# Access Compliance Report

### (Curb Ramps)

Intersection ID: 21939	Main Street: PARK_RD	Cross Street: RIVERBEND_RD	Location: NE
ADA ID: 2631756EB21B	Ramp Type: PerpDiag	Initial Pass/Fail: Fail	Overall Compliance: No
		Severity Score: 37.5

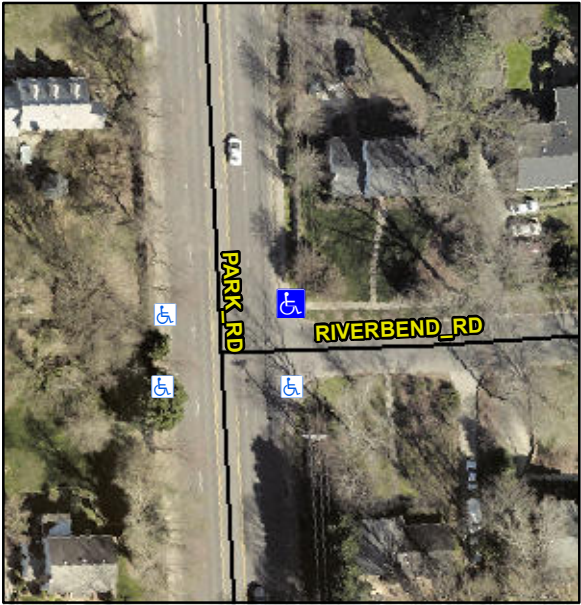
Codes/Mitigation Info/Possible Solution			Field Measurements/Component Compliance		
	Possible Solutions:		<b>Compliance</b>	<b>Description</b>	<b>Data</b>
	<b>Remove &amp; Replace Curb Ramp With Two New Directional Ramps or Equivalent.</b>		<b>No</b>	Ramp Length (in)	80.0
			<b>Yes</b>	Ramp Width (in)	49.0
			<b>N/A</b>	Flare Type LT	N/A
			<b>N/A</b>	Flare Slope LT (%)	N/A
			<b>N/A</b>	Flare Traversable LT?	N/A
			<b>N/A</b>	Landing Length (in)	N/A
			<b>N/A</b>	Landing Width (in)	N/A
			<b>N/A</b>	Landing Slope (%)	N/A
			<b>N/A</b>	Landing X Slope (%)	N/A
			<b>N/A</b>	Landing Curb? (Y/N)	N/A
			<b>N/A</b>	Shared Landing?	N/A
			<b>N/A</b>	Gutter Ponding?	N/A
			<b>N/A</b>	Gutter Lip Ht (in)	N/A
			<b>No</b>	Painted X Walk1?	N/A
				X Walk 1 Direction	To W
			<b>N/A</b>	X Walk 1 Width (in)	N/A
				X Walk 1 Slope (%)	2.6
				X Walk 1 X Slope (%)	3.2
			<b>N/A</b>	Ramp inside XWalk1?	N/A
<p>Surveyor Notes:</p> <p><b>N/A</b></p> <p>PROW/ADA:</p> <p><b>Not Found, R304.2.2, R304.5.3</b></p>			<b>N/A</b>	Flare Type RT	N/A

<b>N/A</b>	Flare Slope RT (%)	N/A
			<b>N/A</b>	Flare Traversable RT?	N/A
			<b>N/A</b>	DWS Provided?	N/A
			<b>N/A</b>	DWS Contrast?	N/A
			<b>N/A</b>	DWS Length (in)	N/A
			<b>N/A</b>	DWS Full Width?	N/A
			<b>N/A</b>	DWS Offset (in)	N/A
			<b>N/A</b>	Gutter Slope (%)	N/A
			<b>N/A</b>	Gutter X Slope (%)	N/A
			<b>No</b>	Painted X Walk2?	N/A
				X Walk 2 Direction	To S
			<b>N/A</b>	X Walk 2 Width (in)	N/A
				X Walk 2 Slope (%)	2.2
				X Walk 2 X Slope (%)	5.9
			<b>N/A</b>	Ramp inside XWalk2?	N/A
			<b>N/A</b>	Clear Space?	N/A
			<b>N/A</b>	Clear Space to XWalk (in)	N/A
			<b>N/A</b>	Storm Grate/Utility Hazard?	N/A
				Storm Grate/Utility Type	
			<b>N/A</b>		N/A
			<b>Yes</b>	Surface Condition? (G/P)	Good
Total Cost:		\$ 3200.00
